#### **GROSS LAND COVERAGE CALCULATIONS WORKSHEET**

# FLOOR AREA CALCULATIONS WORKSHEET

Re: 21 Nethermont Ave - Section, Block & Lot: 122.16/4/41 – Response to RPRC Determination Letter

SCALE: 1" = 15' DATE: SEPTEMBER 10, 2020 DRAWN BY: CHECKED BY: ES. TS - 1 SHEET 2 of 6

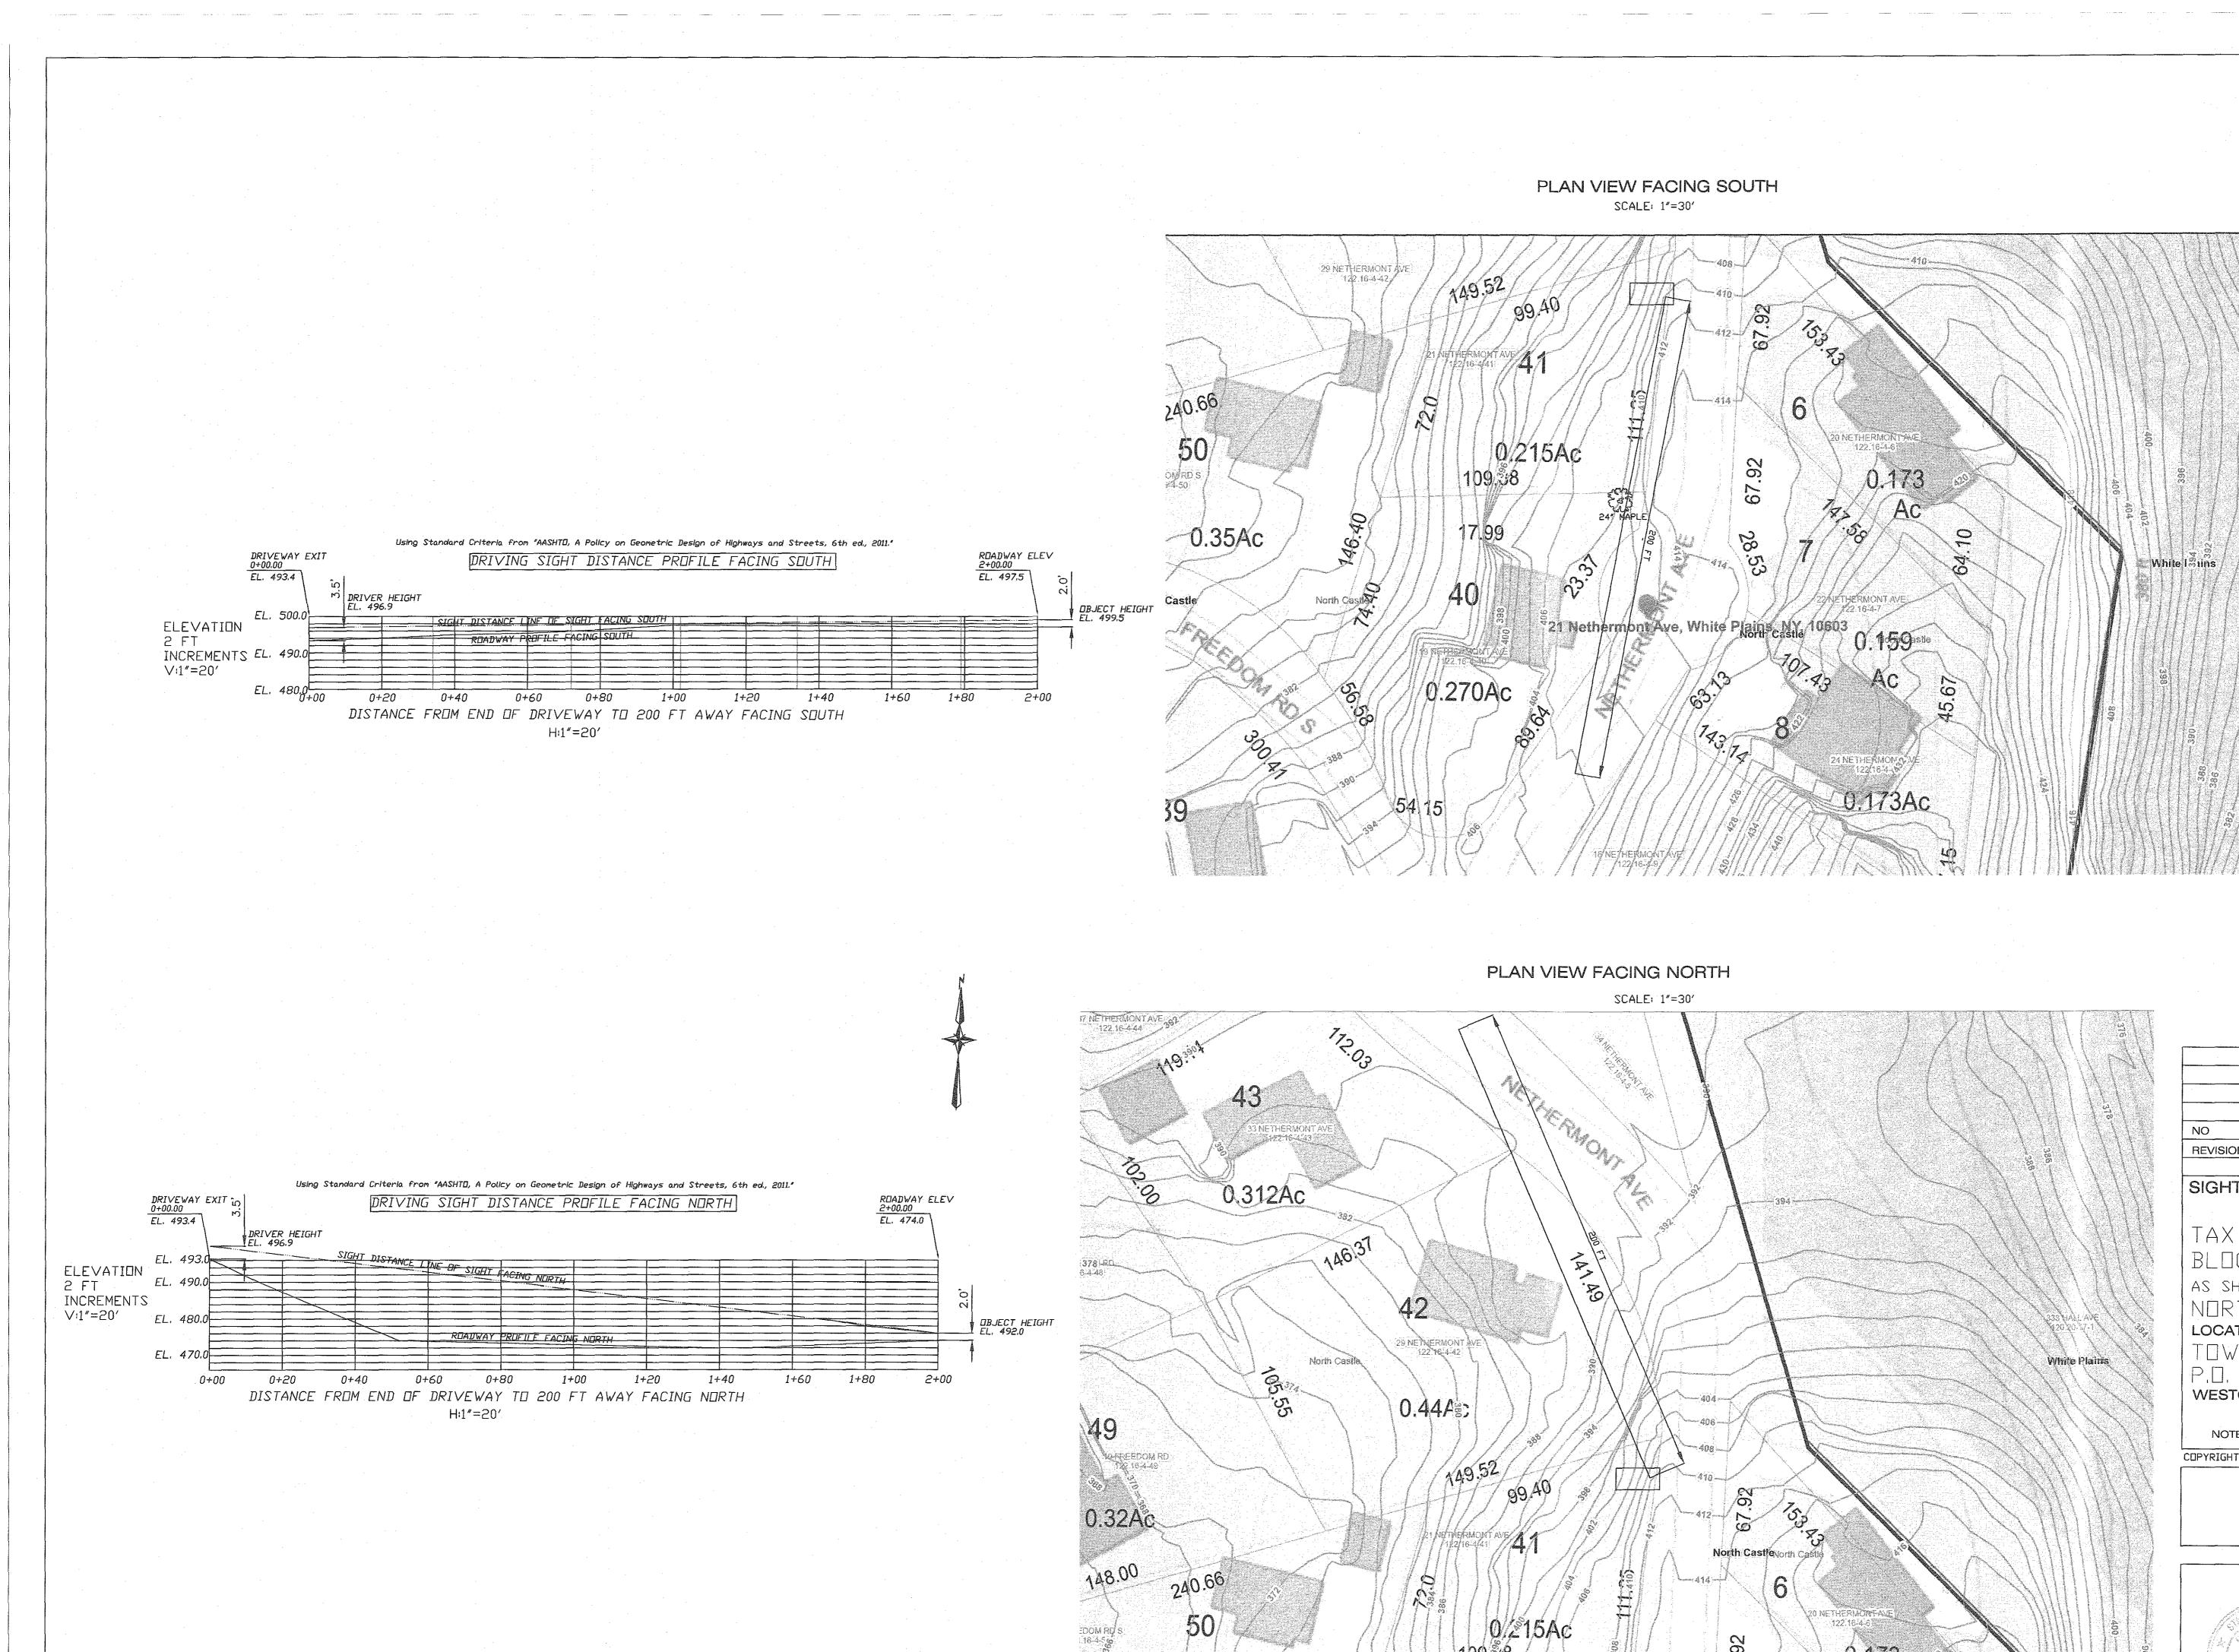
- See GABRIEL E SENOR P.C. Site Plan Package Steep Slope Analysis sheet 2 of 6, TS-1 where all steep slope areas and disturbance within the steep slope areas are clearly shown.
